Our Ref: N:\37672 Northbank\Worddocs\Report\NSW DoPI Additional Information Request November 2012

NORTHBANK ENTERPRISE HUB (MP 10_0185)

SECTION A
TYPICAL
SCALE 1:75

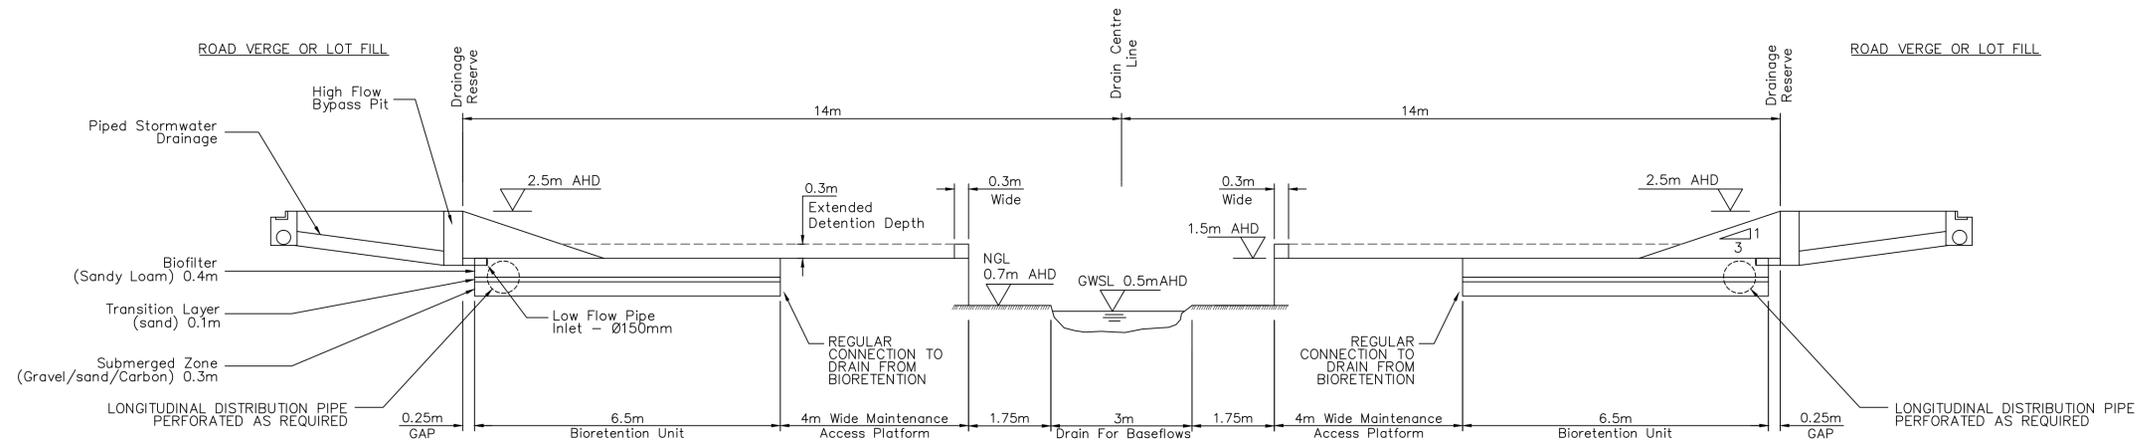
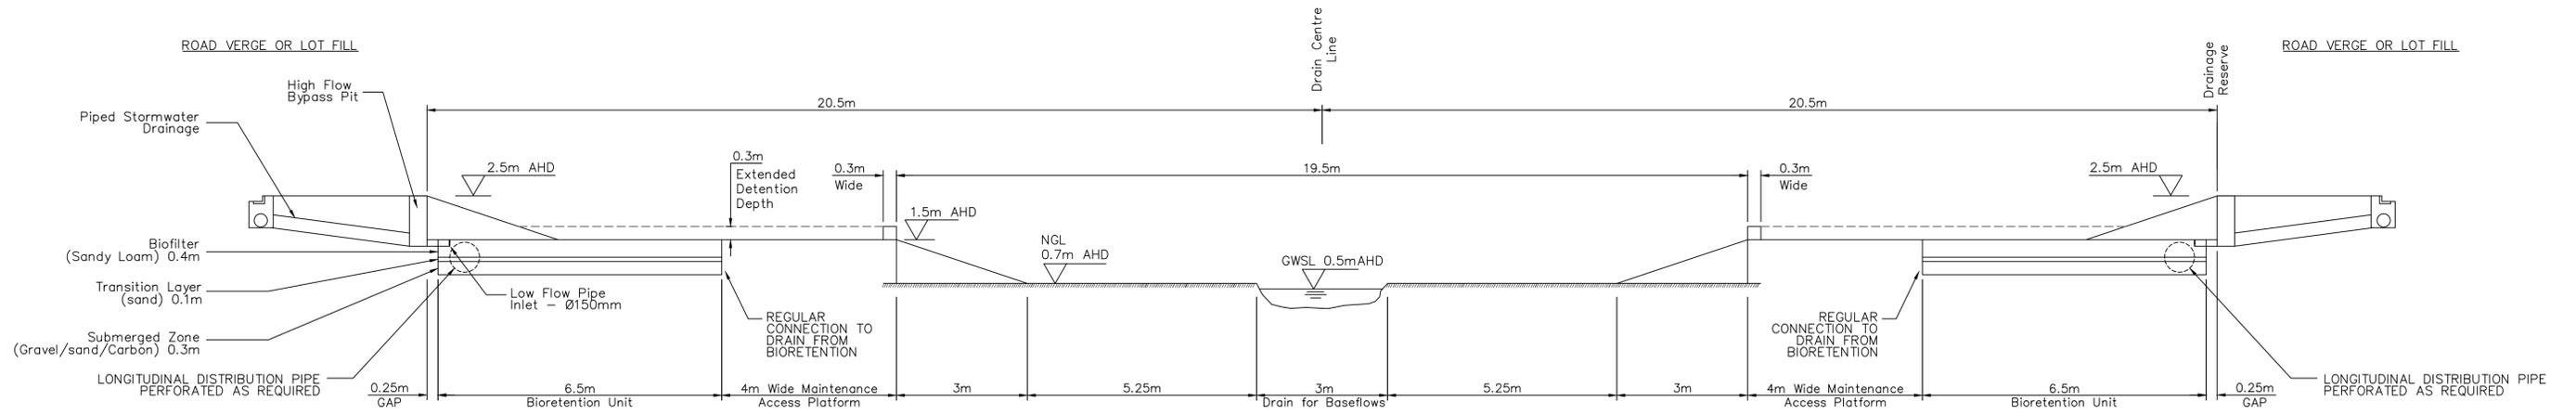
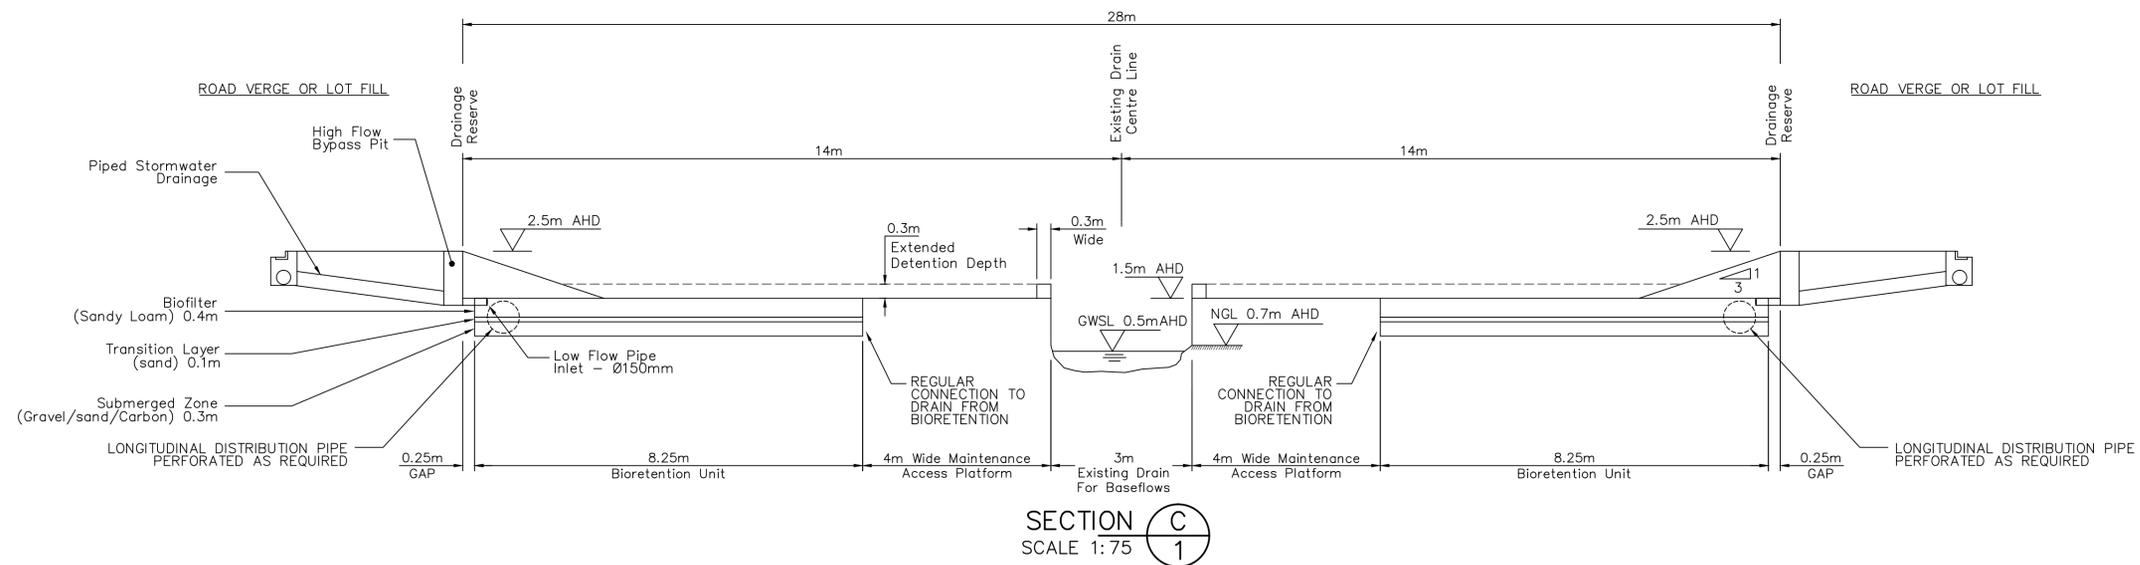
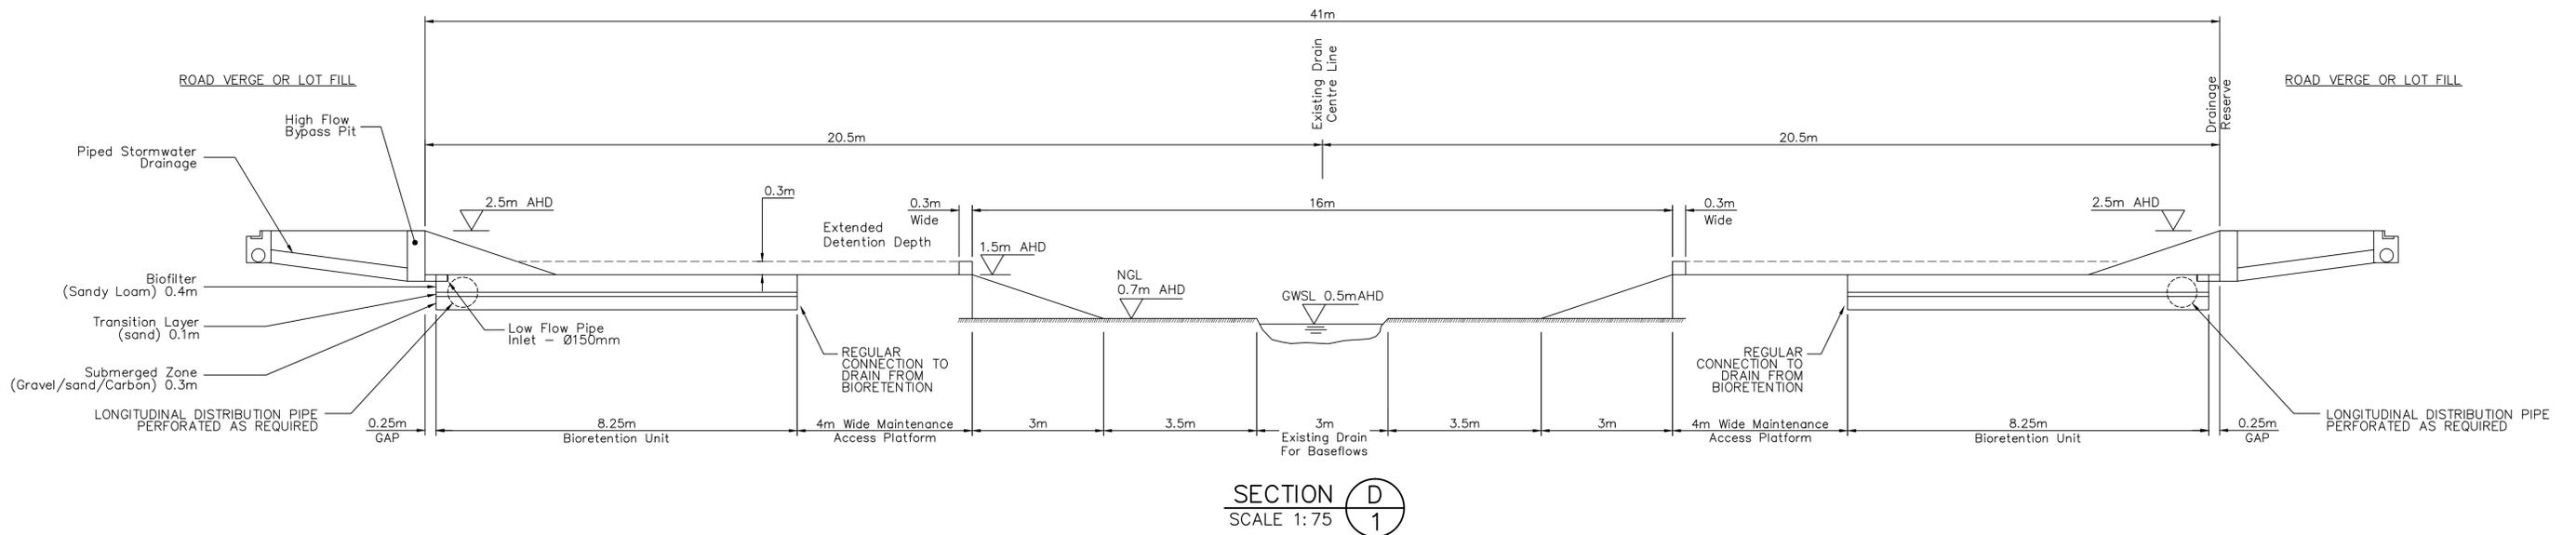
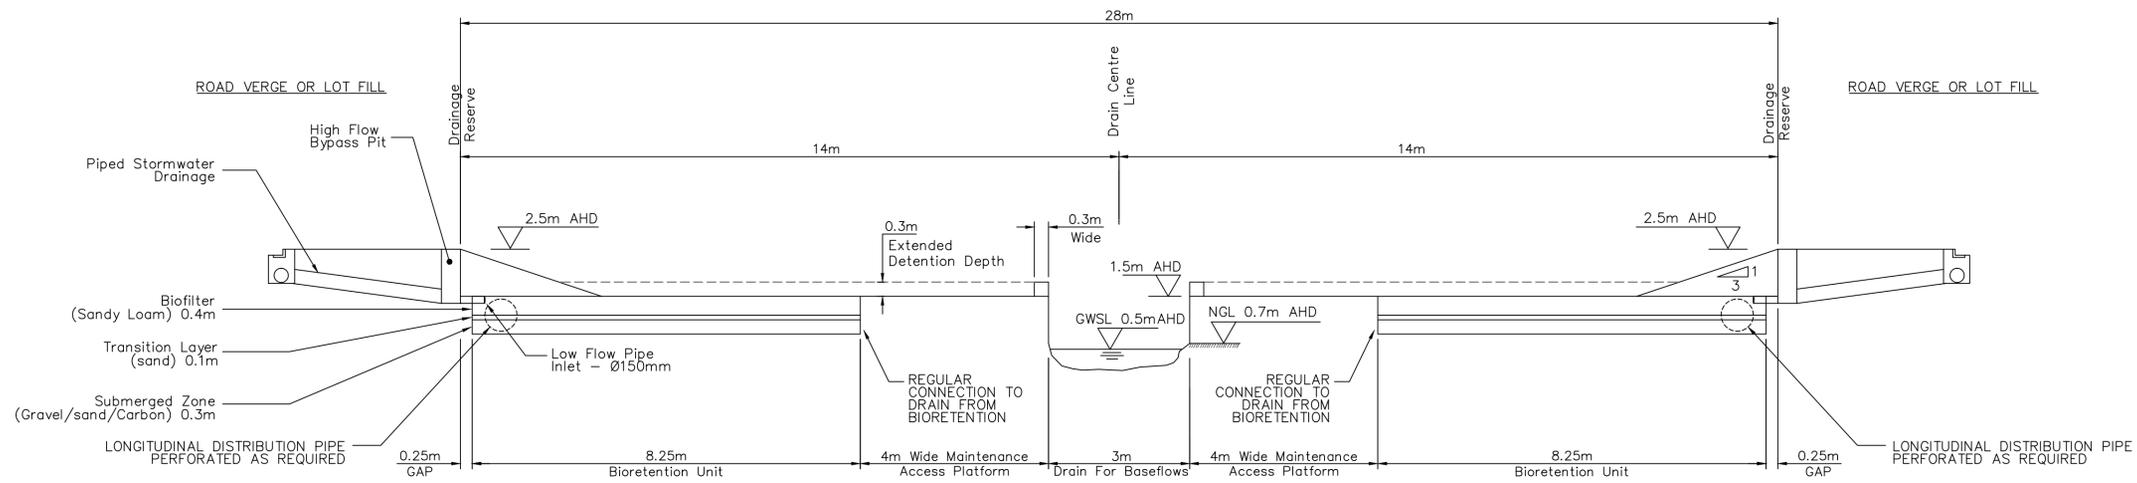
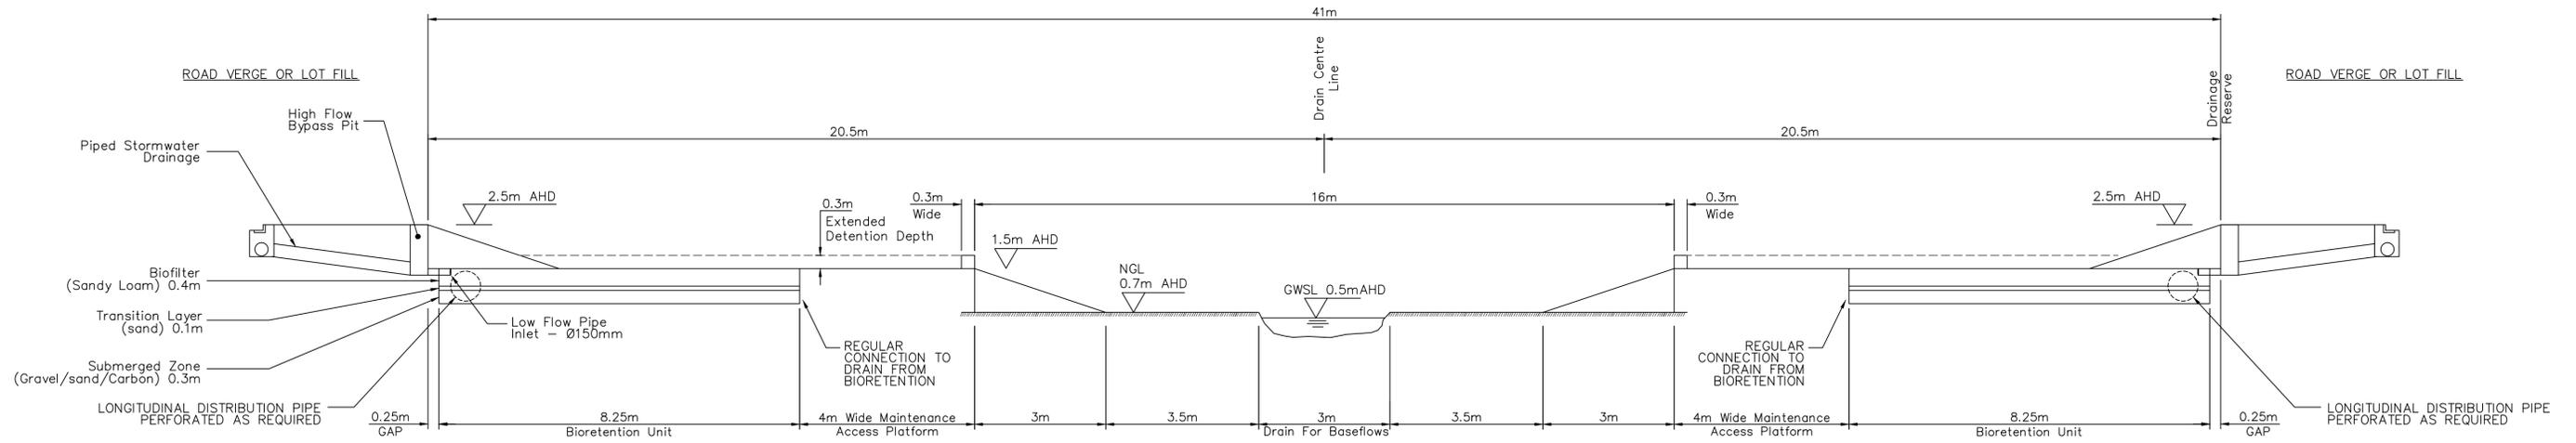
At your request we have prepared a section through the overflow wetland that is contained within Sheet 6. This clearly demonstrates that low flows will not escape at this location.
